Product Change Notification / ASER-19HIWO872

CCB 4748 Final Notice: Qualification of MTAI as an additional assembly site for selected ATMEGA324PBxxx and PIC16F1xxx device families available in 44L TQFP (10x10x1mm) package.

PCN #: ASER-19HIWO872

Lead Frame Comparison

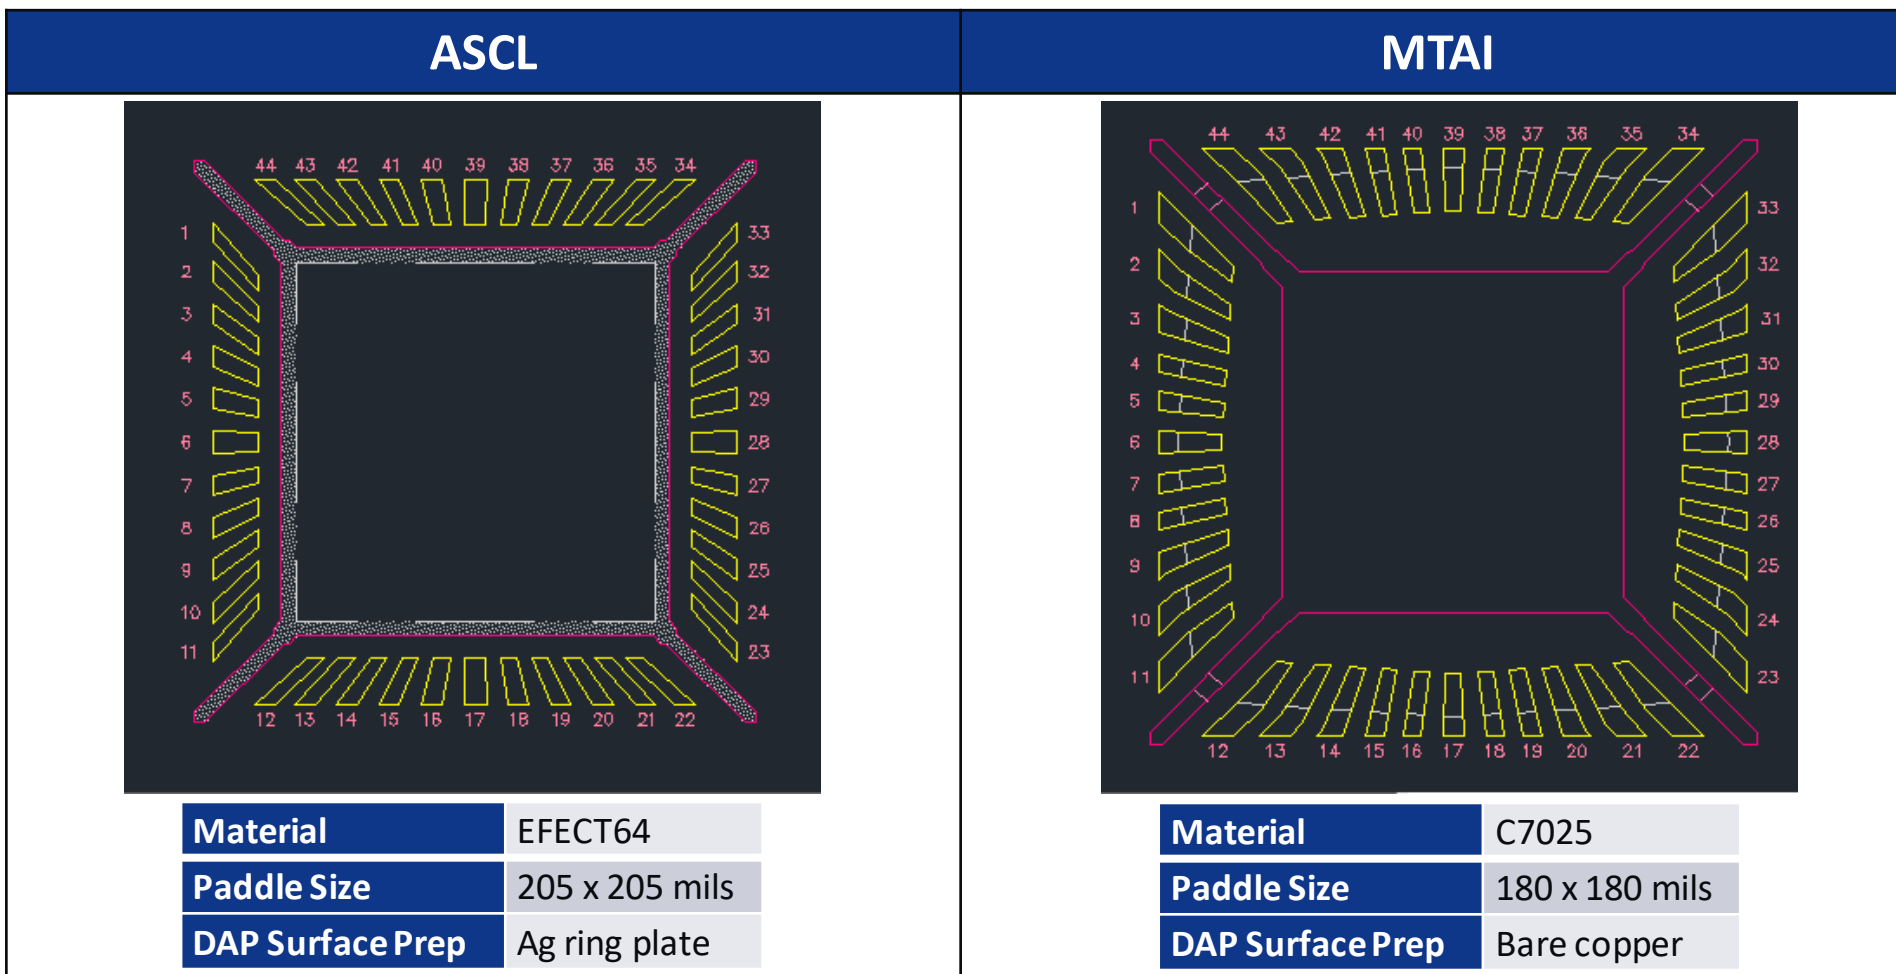
CCB 4748
Pre and Post Change Summary
PCN #: ASER-19HIWO872
